STAFF REPORT
DATE: 12/12/2023
WORKSHOP DISCUSSION

TO: City Council
FROM: Nathan Fuerst, AICP, Consulting Planner
AGENDA ITEM: **Sketch Plan Review – Eberhard Property Proposal by Rachel Development**
REVIEWED BY: Sophia Jensen, City Planner
Jenni Faulkner, Senior Consulting Planner

RE: Eberhard Property – Revised Concept Review

To: Sophia Jensen, City Planner
Cc: Nathan Fuesrt, Planning Consultant
Marty Powers, Public Works Director
Chad Isakson, PE, Assistant City Engineer
From: Jack Griffin, PE, City Engineer
Re: Eberhard OP (Rachel Development) Sketch Plan

TITLE SHEET

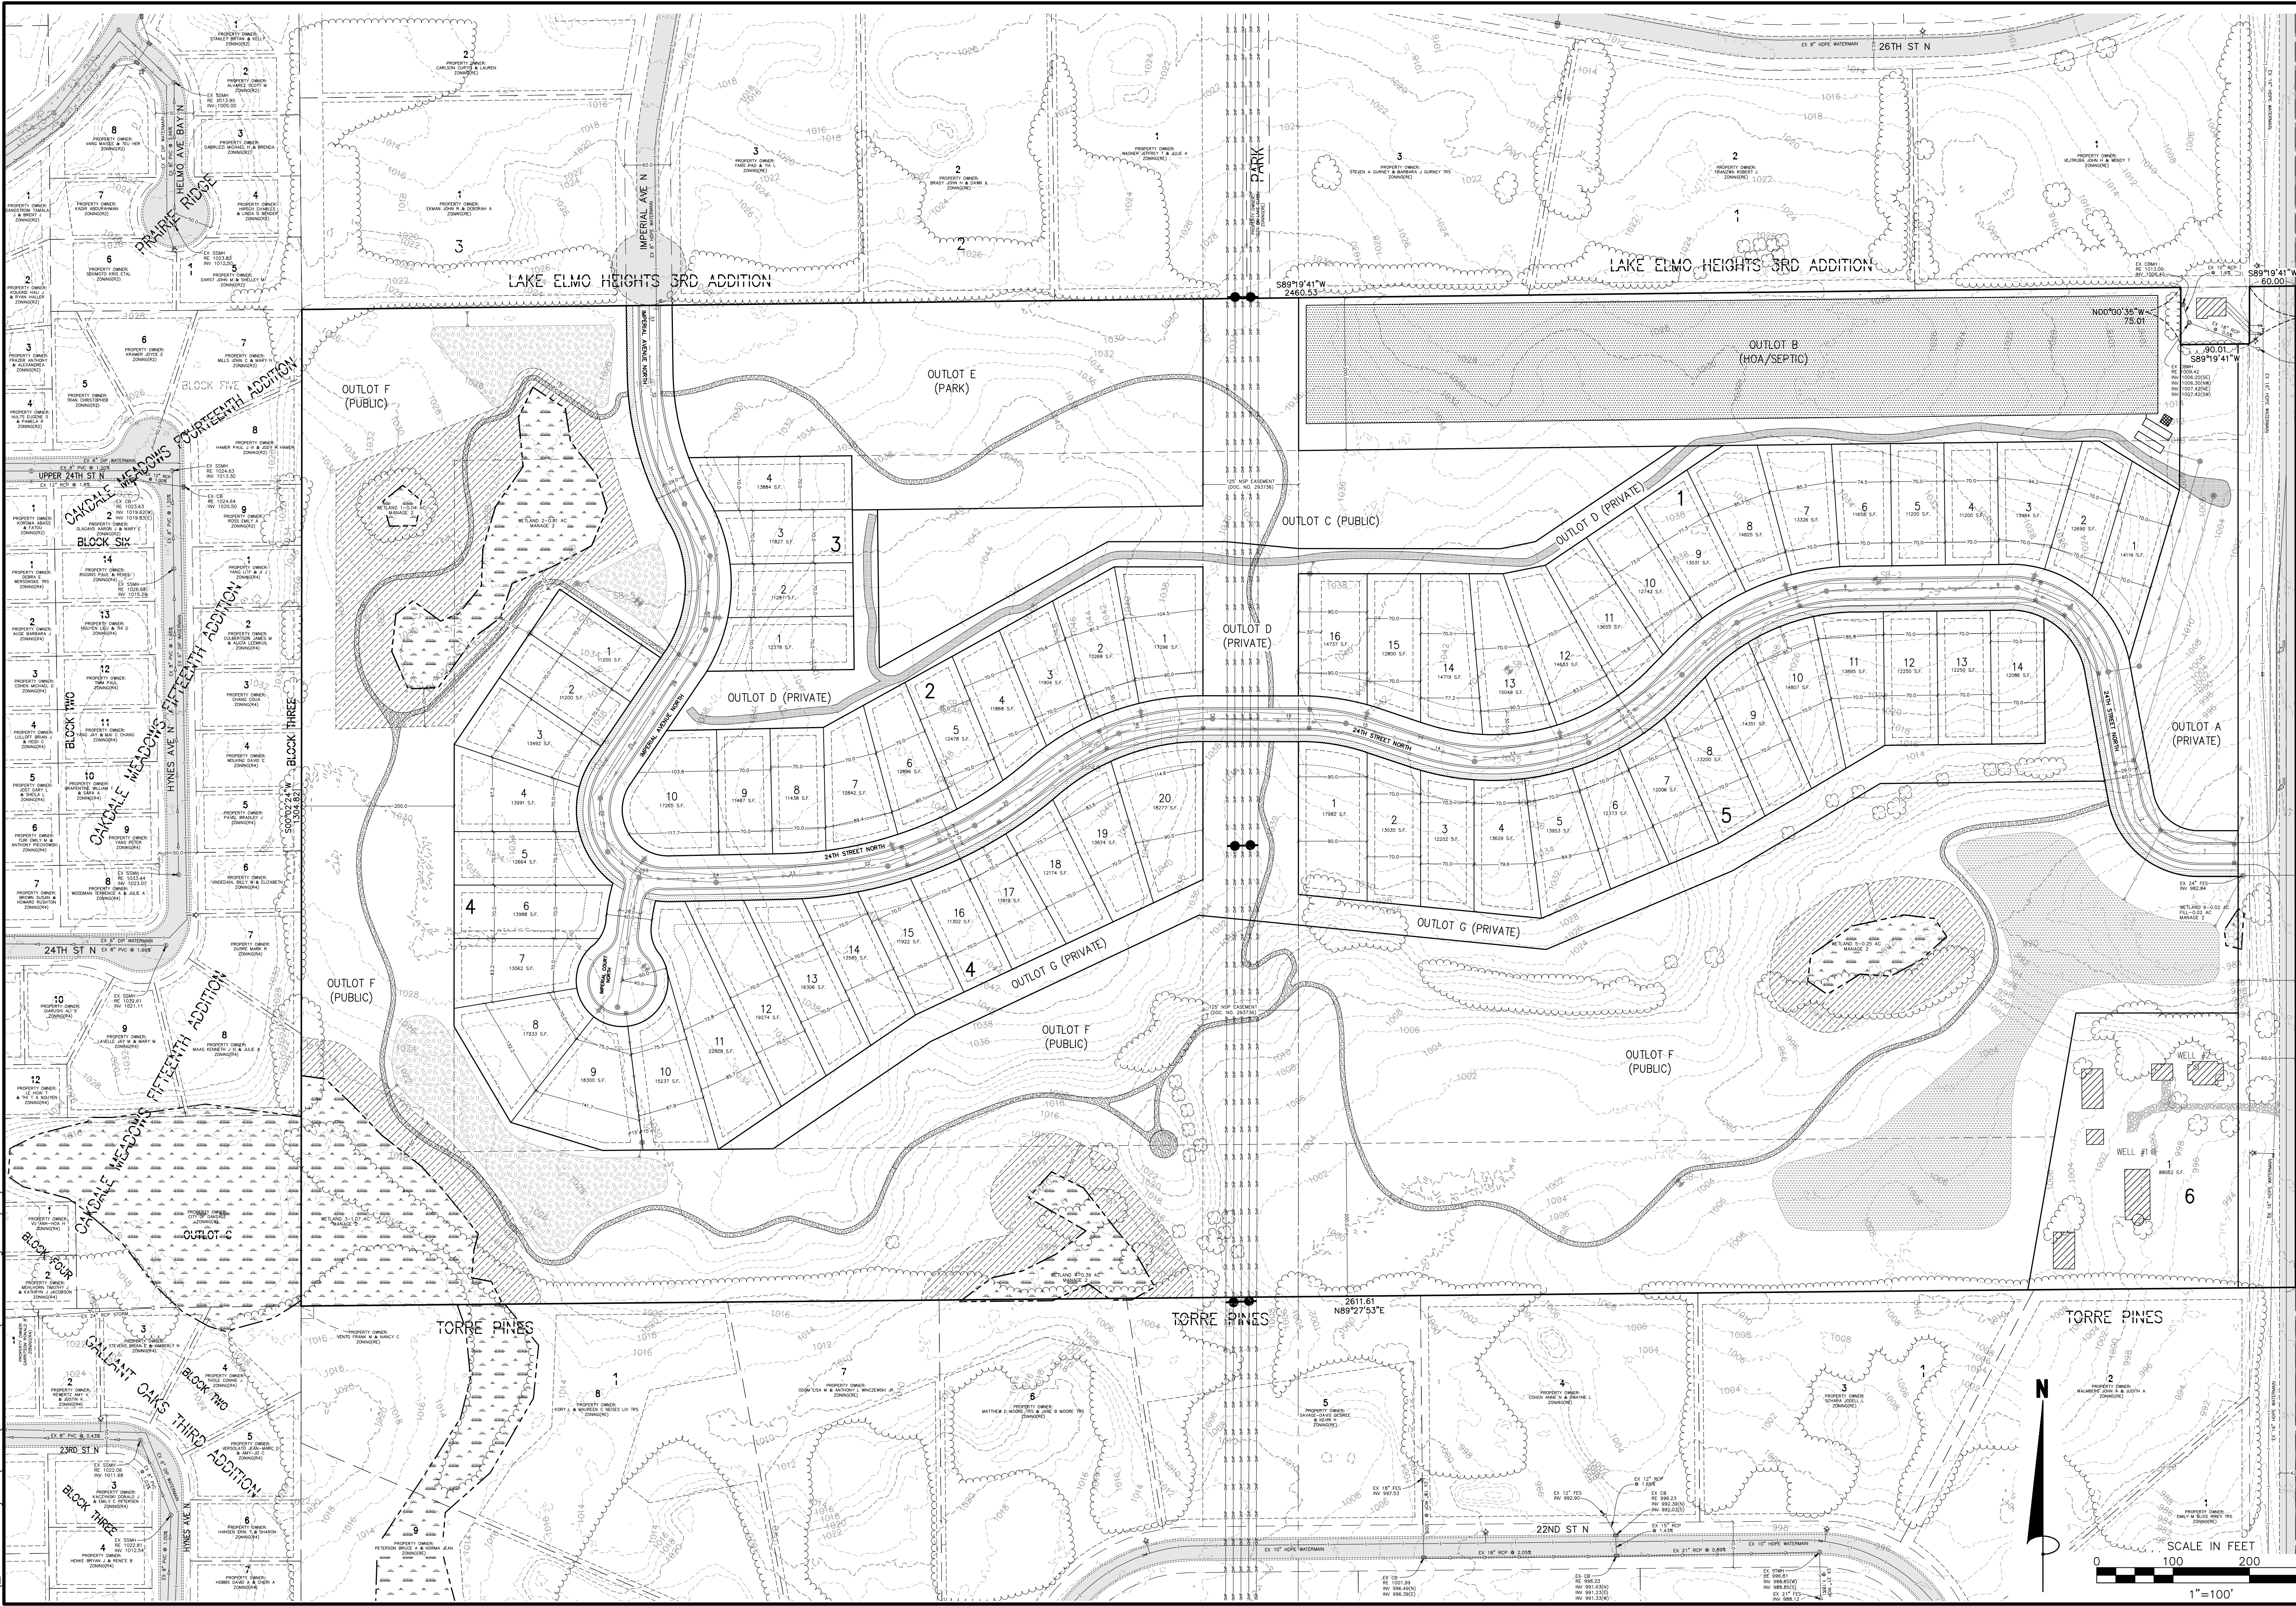
1. *Soils Analysis Conducted.* – Report and map are provided indicating best location for community septic based on known soils. More detail on whether Karst soils are present will be required at Preliminary Plat. **(Need Info)**
2. *Septic Design* – The project proposes a community septic system. Location(s) suitable for community drain field need to be provided on the plans **(Met)**
3. *Buffers* – 200' from adjacent residential **(Met)**
4. *Identification on preferred building pad locations* – Shown on sheet 4.00. City

6. *Lot Creation* – Lots shown on plans with smallest proposed lot at 11200 sq ft. Minimum lot size of 21,780 sq feet for lots served by communal drain fields is not met, explanation for PUD request in Narrative. Plan page 4.0 provides information on location of soils, slopes, and setbacks. **(Not Met – Flexibility Requested)**

DRAWN BY	CJK
DATE	9/22/23
REVISIONS	
	11/8/23 REVISED LAYOUT
	11/17/23 REVISED CONCEPT
CAD FILE	24110CP
PROJECT NO.	24110
	2.00

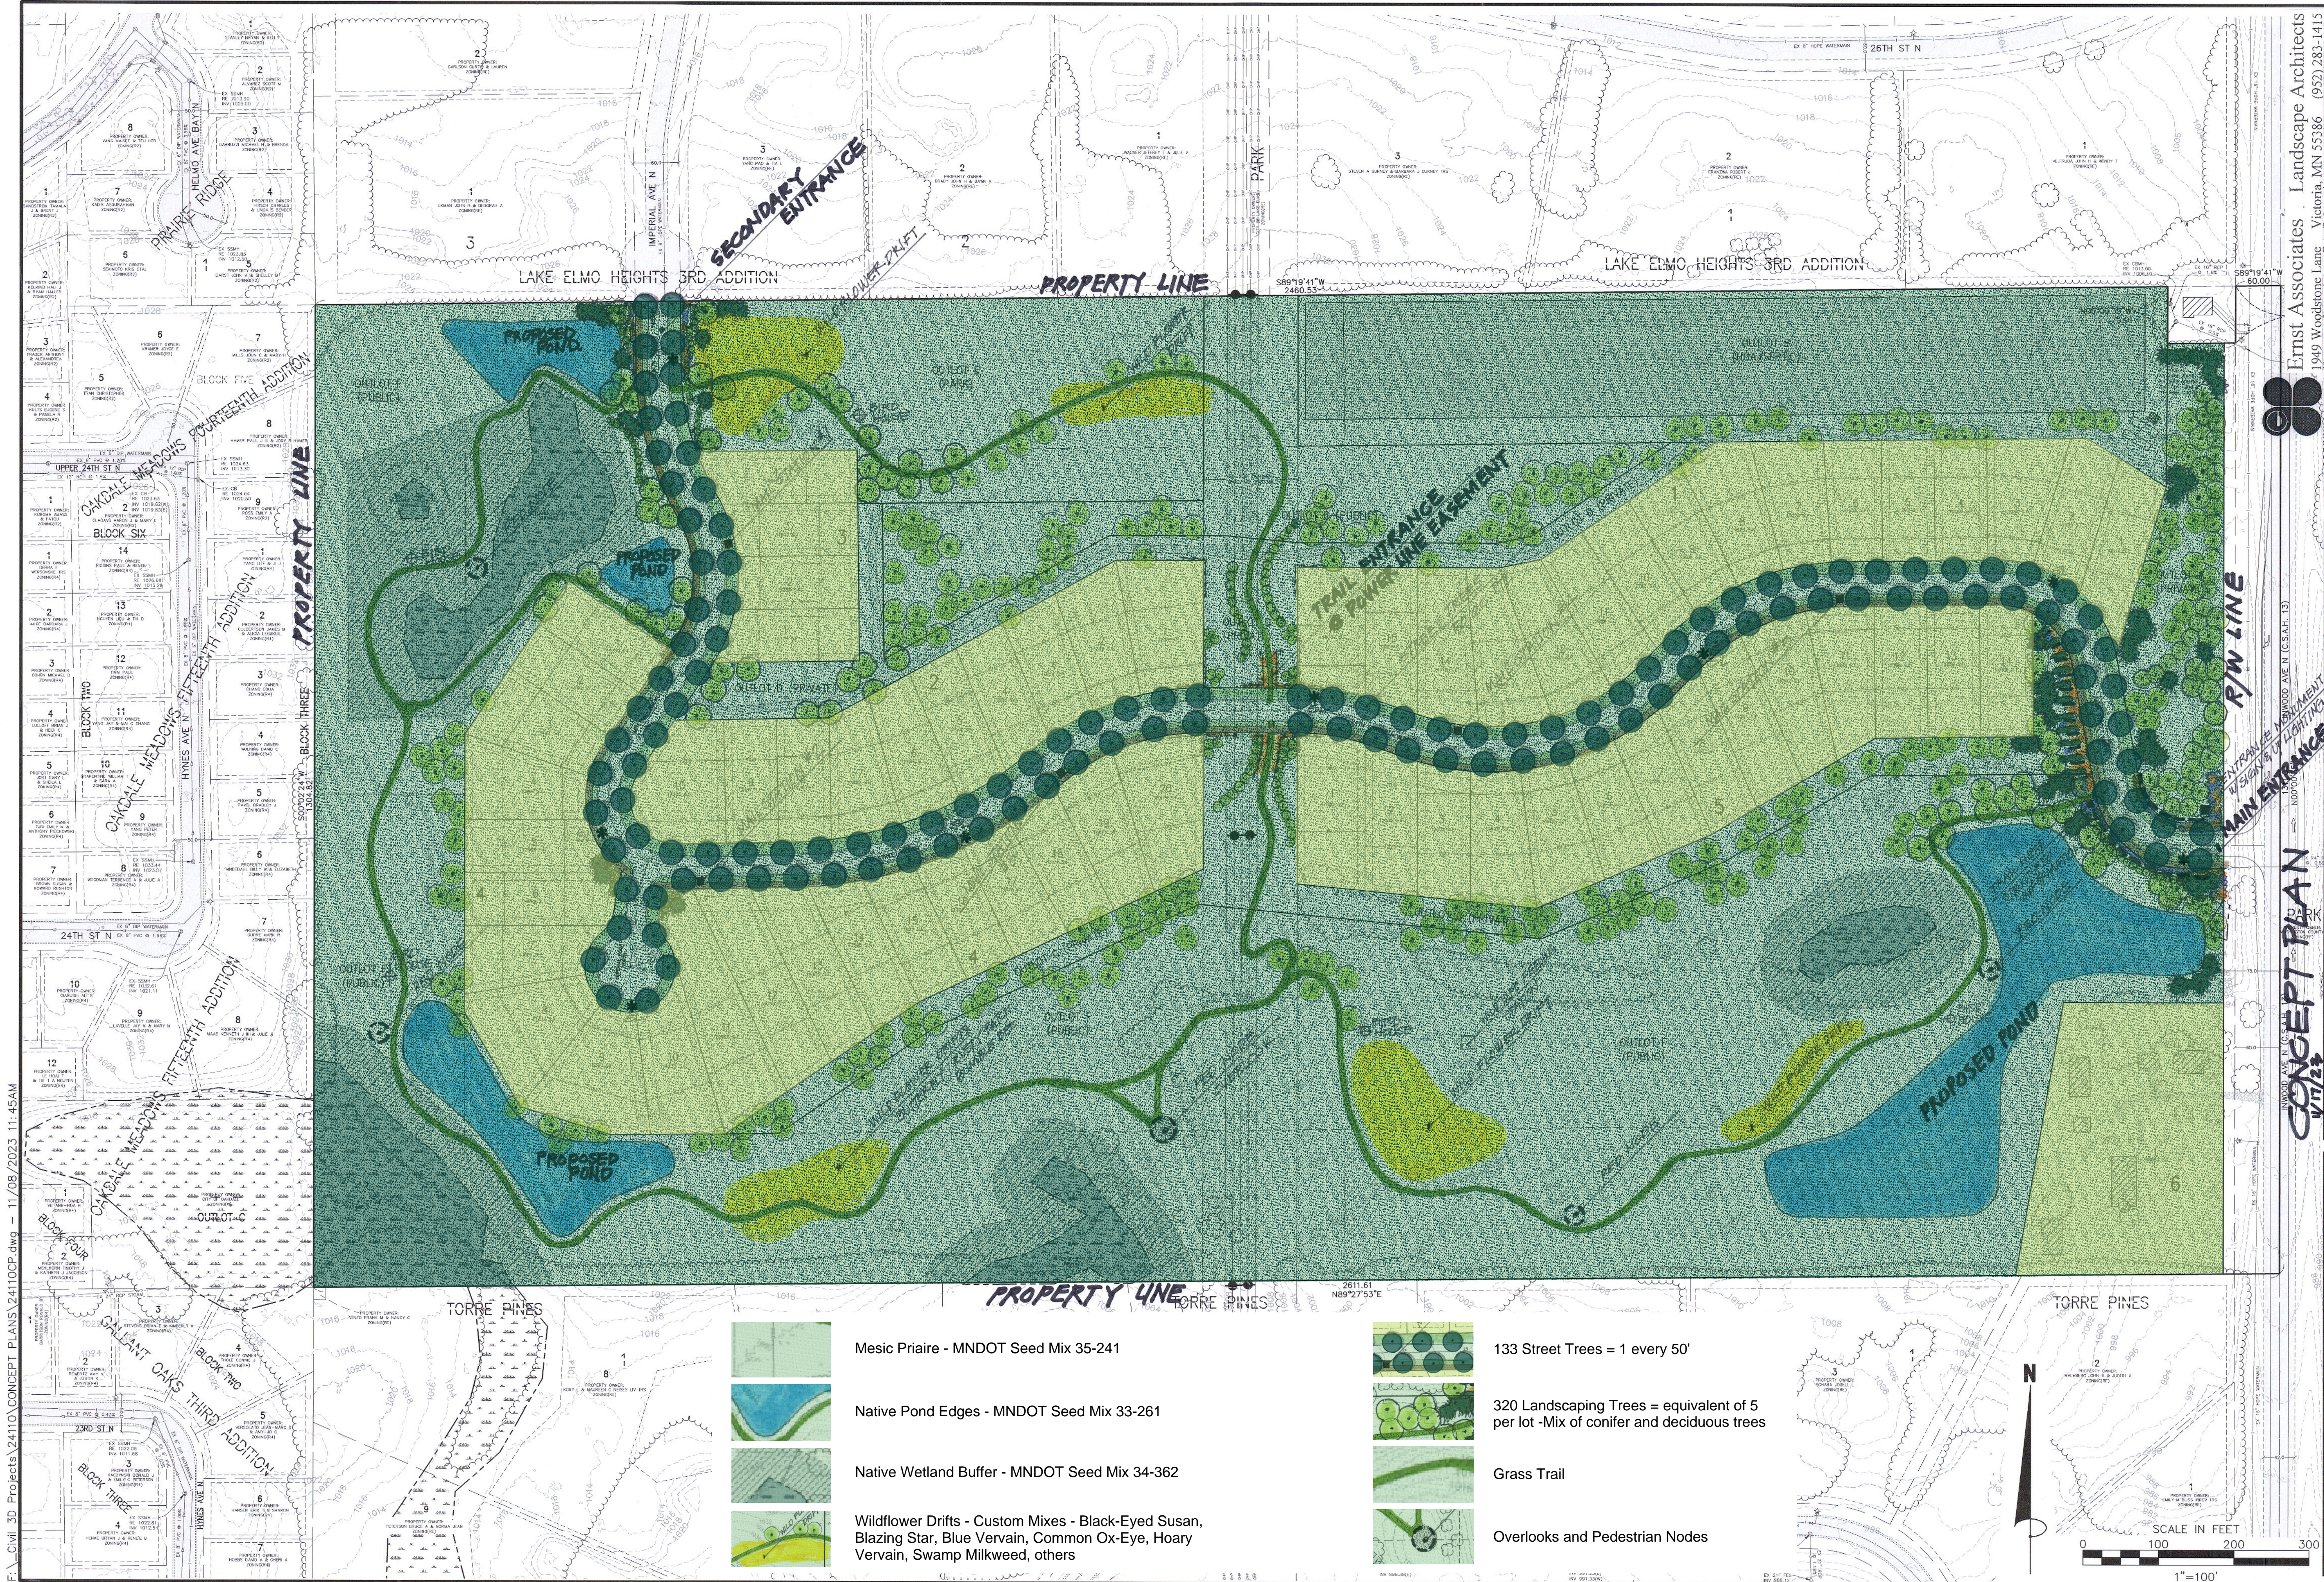
1. Inwood Avenue Right-of-way dedication. Right-of-way dedication will be required as part of the Plat including 75 feet as measured from the existing roadway centerline. Right-of-way dedication has been shown on the Sketch Plan as required.

5. Phasing Plan. The development phasing will require the secondary connection to Imperial Avenue to be operational before the 31st building permit will be issued. Access for the initial phases of development should be prohibited from Imperial Avenue to avoid construction traffic through the existing Lake Elmo Heights neighborhood. Temporary cul-de-sacs meeting City design standards will be required as the development is phased.

6. A public street is proposed on the Sketch Plan with a 28-ft wide street within a 60-ft right-of-way. City design standards currently require a 32-ft wide street within a 66-ft right-of-way to allow parking on both sides. For low density open space developments, the city has allowed for a 28-ft wide street within a 60-ft right-of-way with parking permitted on only one side of the street, however the lot frontage and density

8. Street intersections must connect at 90 degrees and maintain 50 feet of tangent with maximum slopes of 2.5%. The cul-de-sac (Imperial Court North) intersection with 24th Street North must be revised accordingly, and the intersection relocated to provide proper sight lines. Residential maximum longitudinal grade is 6%. All cul-de-sacs must meet City design standards for minimum diameter of 90 feet, minimum right-of-way diameter of 120 feet, and signed "No parking" throughout.

11. City design standards require a six (6) foot sidewalk along all residential streets. The Sketch Plan shows an 8-ft bituminous trail in place of the sidewalk. If the trail replacement is approved by the City, the trail should be in addition to the required sidewalk.

12. Trail Requirements. The Open Space PUD ordinance requires a trail system to be established equal in length to the sum of the centerline length of all public roads within the development. The Sketch plan provides this trail as required; however, it is being proposed instead of the required sidewalk.

13. Ten (10) foot utility easements are required on either side of all public right-of-way. The 10-ft. easement corridor must be preserved for the installation of small/dry utilities and remain free from all encroachments, and graded to a maximum 4% grade per city detail 805.

14. Driveways. No driveways were shown as part of the Sketch Plan. All driveways must be installed in accordance with all city ordinances, including minimum distance from intersections, driveway angles installed at 90-degrees as they cross public right-of-way, and distance between driveways. Revisions to the lot layouts may be necessary for driveway compliance.
